<u>SP-24-09</u>	<b>Staff Report – July 29, 2024</b>
<b>Application Type:</b>	Special Use Permit
<b>Project Address:</b>	1601 Lemoyne Avenue (Tax Map ID: 004.-05-03.0), 1611 Lemoyne Avenue To City Line, (Tax Map ID: 004.-05-02.0), 1585 Lemoyne Avenue (Tax Map ID: 004.-05-04.1)
<b>Summary of Proposed Action:</b>	<p>The applicant (Cuse Car Care, LLC.) proposes to change the land use from a heavy automobile repair use type to a light automobile repair use type and build a 2,920 SF (footprint) addition onto the existing building. The existing heavy automobile repair use type is a legal non-conforming land use in the Mixed-Use Transition, MX-3 Zone District. The light automobile repair use type is a conforming use and only permitted by a Special Use Permit in the MX-3 Zone District.</p> <p>The applicant also intends to combine three existing lots (1601 Lemoyne Ave., 1611 Lemoyne Ave., and 1585 Lemoyne Ave.) to become one new lot (new 1601 Lemoyne Ave.) for the proposed light automobile repair use and proposed building expansion.</p> <p>The total gross floor area of the proposed building is 5,840 SF (2-story) and the existing building is 3,165 SF (1 story). The total gross floor area of t

SHEET NUMBER  
**L-1**

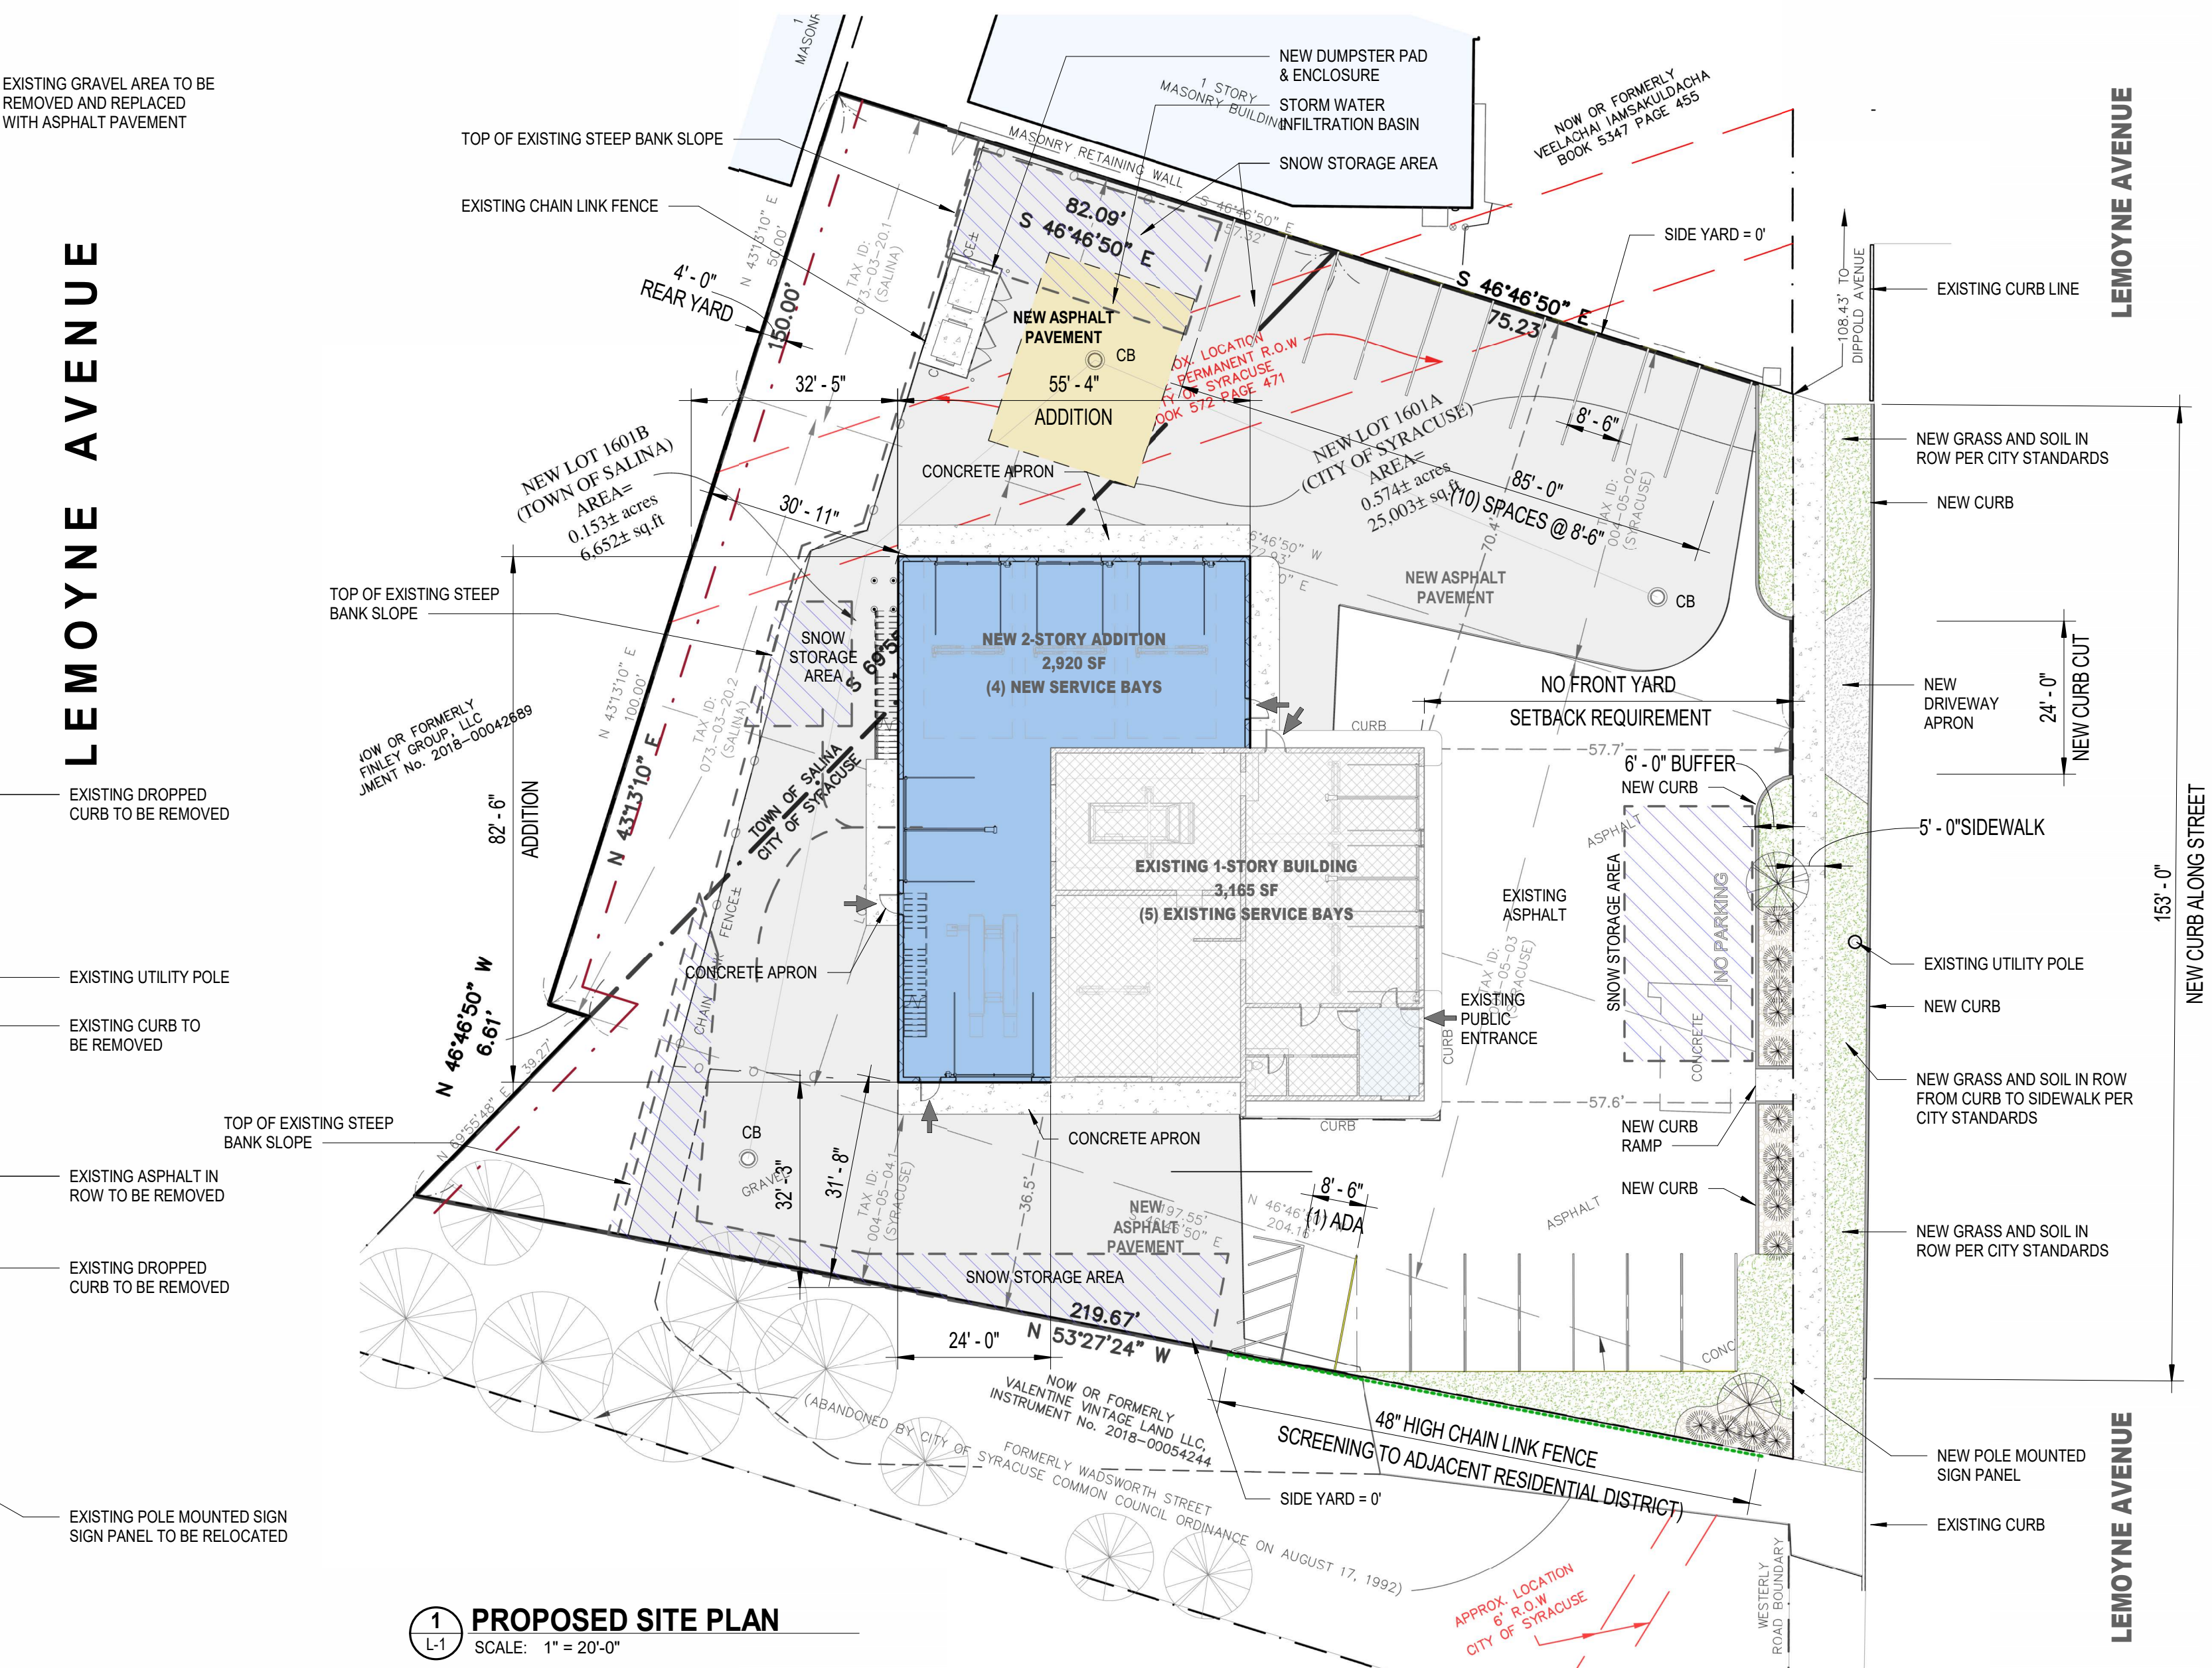
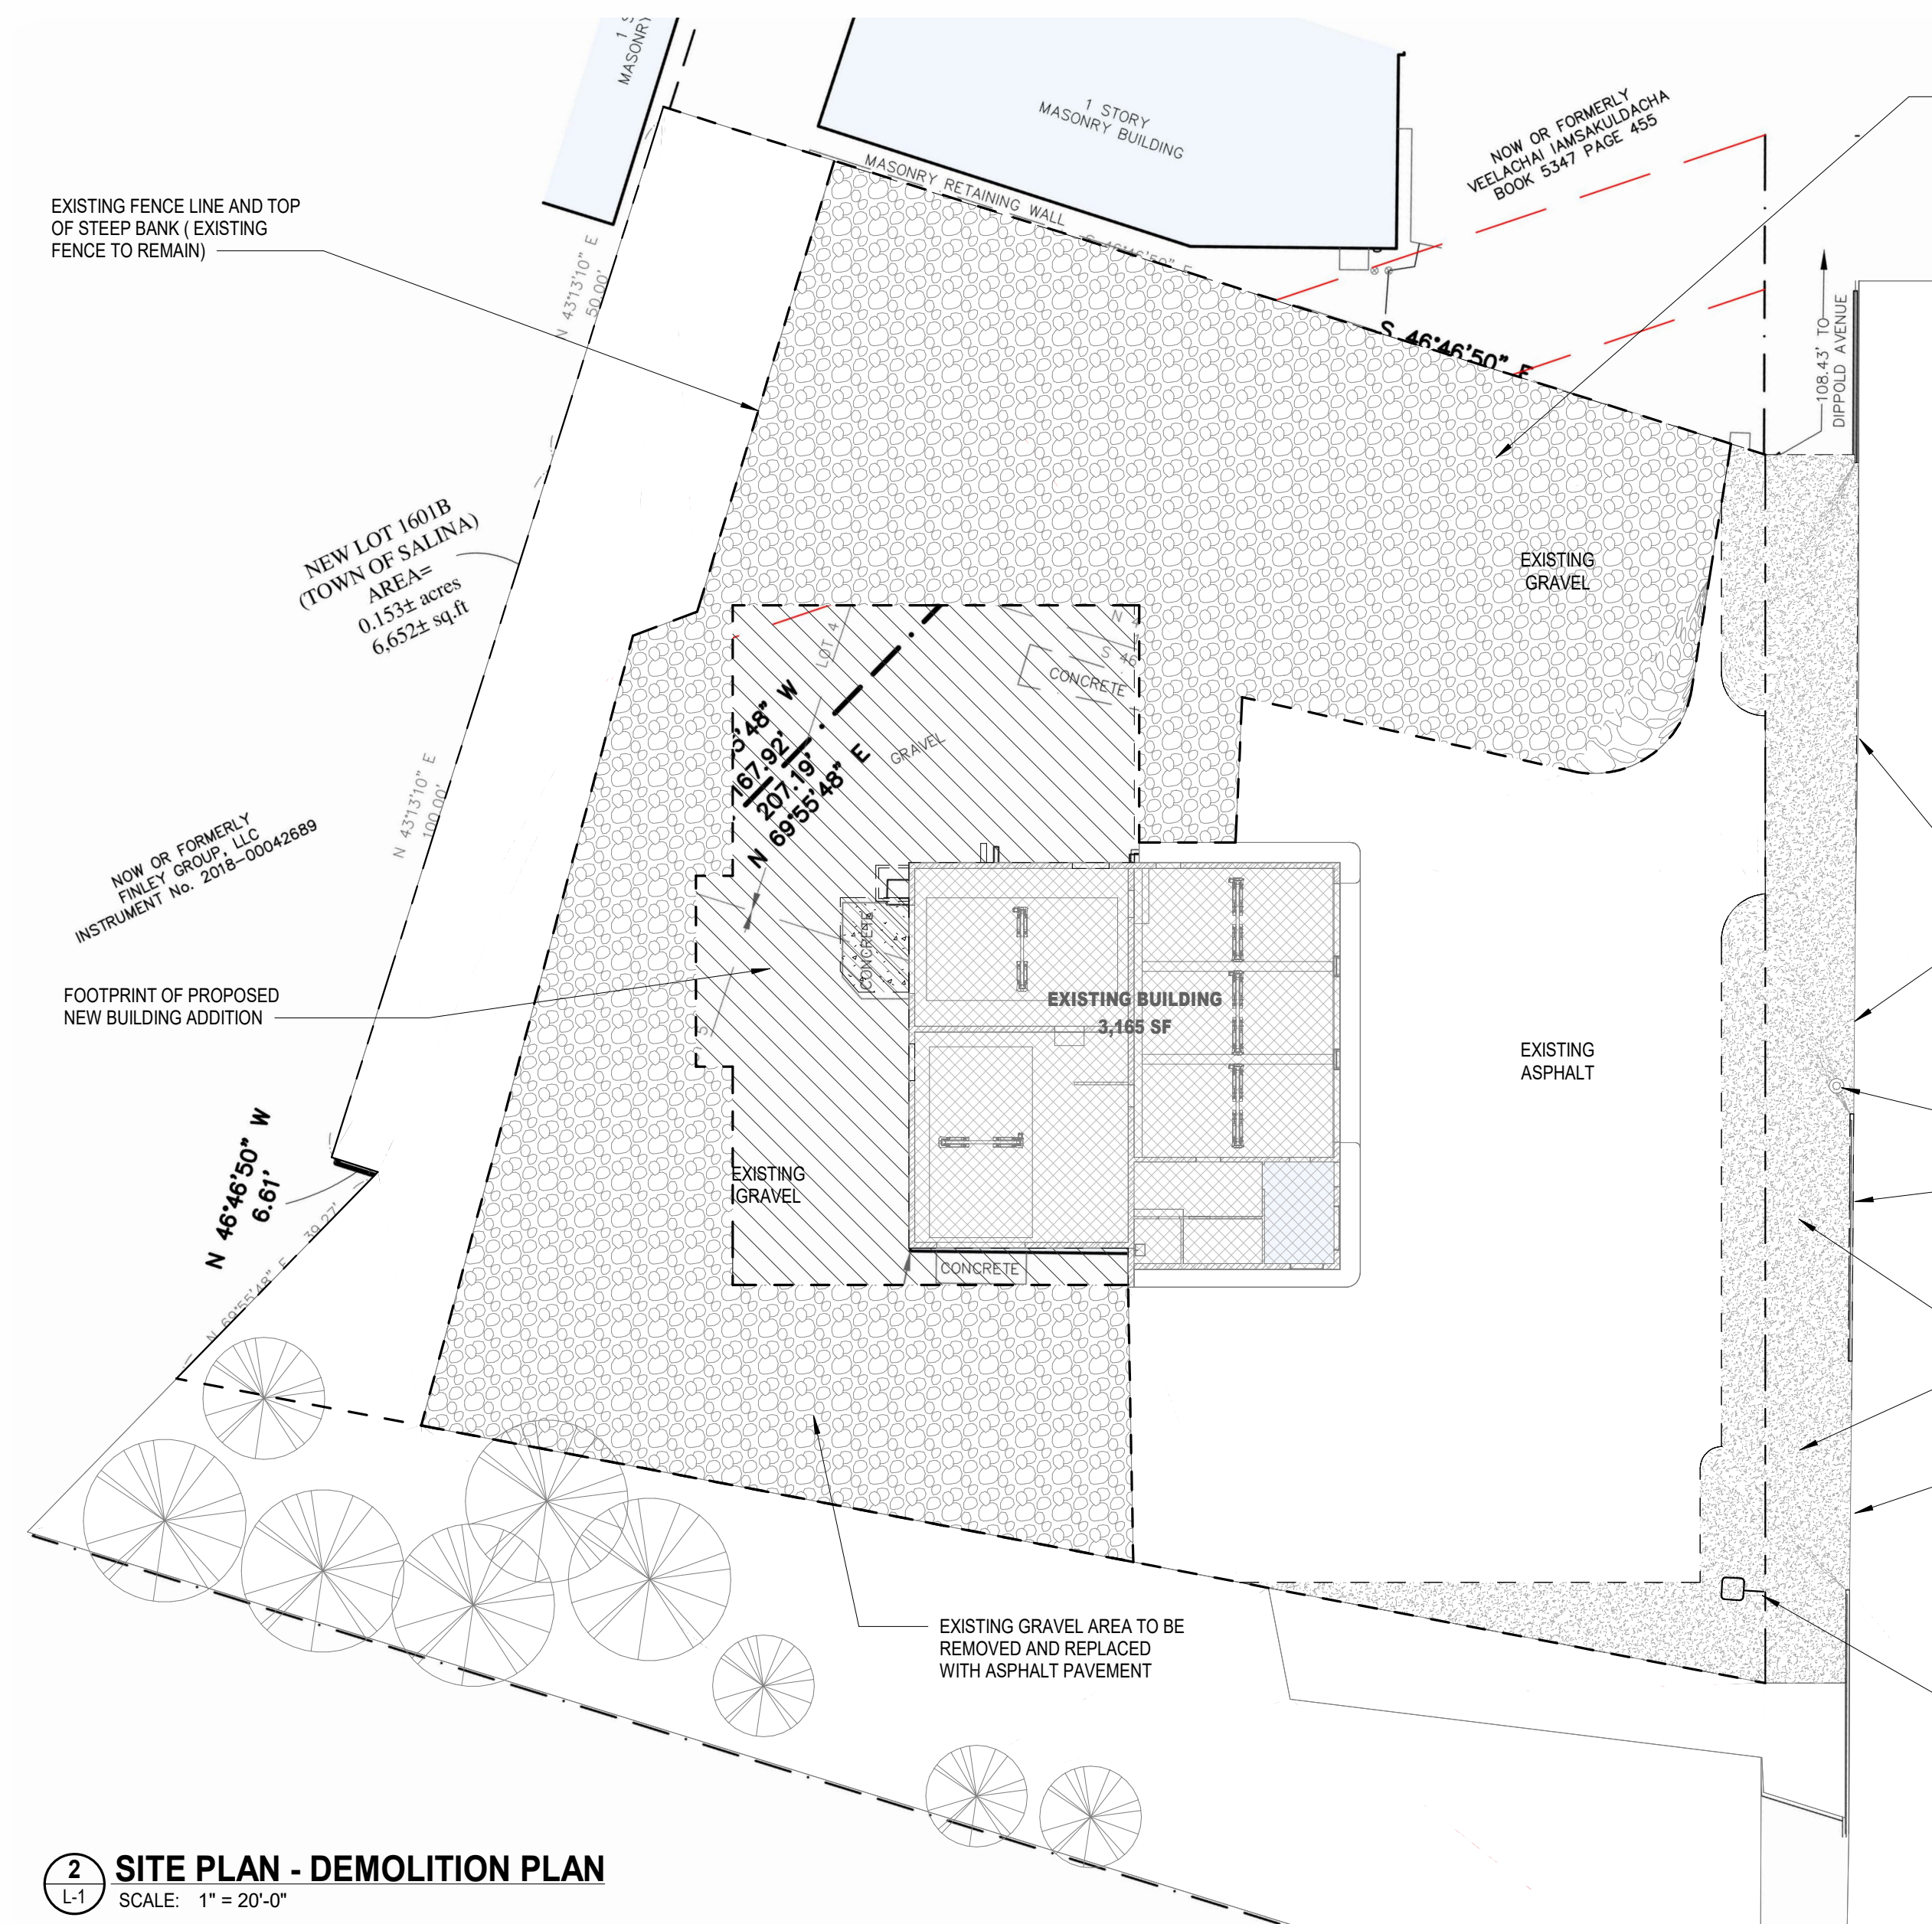
1. The applicant is required to coordinate with the Onondaga County Department of Transportation regarding access plans and establish formal driveway access to LeMoyne Avenue in conformance with commercial driveway standards. The municipality must ensure any mitigation as may be determined by the Department is reflected on the project plans prior to, or as a condition of, municipal approval.
2. The applicant and City must coordinate a multi-municipal review of the proposed project with the Town of Salina.
3. The applicant and municipality are encouraged to improve appearance of the

- Parking area to be curbed/incorporate fixed vertical objects (no wheel stops) along all sides.
- Parking area to incorporate greenspace buffer, 5' or greater along entirety of Lemoyne ave frontage outside of driveway opening, measured inwards from property line. To include perirenal plant material/trees/etc.
- Planting plan required, grading/drainage plan may impact/increase buffer requirements.
- ADA compliant walkway to/from the main entrance and public ROW/sidewalk required, typically aligned with loading area of accessible parking stalls.

DPW - Sanitation & Sewers	On Hold	04/17/2024	Vinny Esposito	<p>please provide a drainage plan, The site will be nearly 100% impervious as per plan. Storm water must be mediated to an extent, dry wells or re-charge trenches. Also the sewer in the 20' ROW must be located precisely as I believe this is a 30" storm sewer.</p>
DPW - Traffic Control	Conditionally	04/23/2024	Charles	4.23.24 Conditionally Approved.

Approved		Gafrancesco	No sidewalk closures or obstructions or road or lane closures will be allowed as part of this work unless accompanied by MUTCD compliant detour.
Zoning Planner	On Hold	04/17/2024	Haohui Pan	Updated plan needs: The east side of the building that abutting the adjacent Residential Zone shall be fenced.
Engineering - Stormwater (SWPPP)	Conditionally Approved	04/25/2024	Mirza Malkoc	<ul style="list-style-type: none"> <li>• All construction in the R.O.W. will require a road cut permit, all construction in the R.O.W. to be per City standards and specifications.</li> <li>• Complete set of the stamped engineering site plans with specific details are required to complete a detailed project permit review.</li> <li>• Designer shall clearly indicate on the site plans how much soil disturbance this project will create. If the soil disturbance is over 10,000sf then a SWPPP is required but if the soil disturbance is less than 10,000sf then the designer need to do some improvements to the site by capturing the stormwater sheet flow and treating it before discharging it to the City's ROW.</li> <li>• Proposed grading shall be graded to prevent stormwater sheet flow to adjoining properties &amp; to the City R.O.W.</li> <li>• The Project is subject to Onondaga County's 1:1 offset. The City requires an offset plan &amp; details for review. Applicant shall submit sanitary flow data to the Engineering Department, the determined offset plan then most likely will require Common Council Approval.</li> <li>• Onondaga County Plumbing Control shall review and approve the plans as well.</li> </ul>
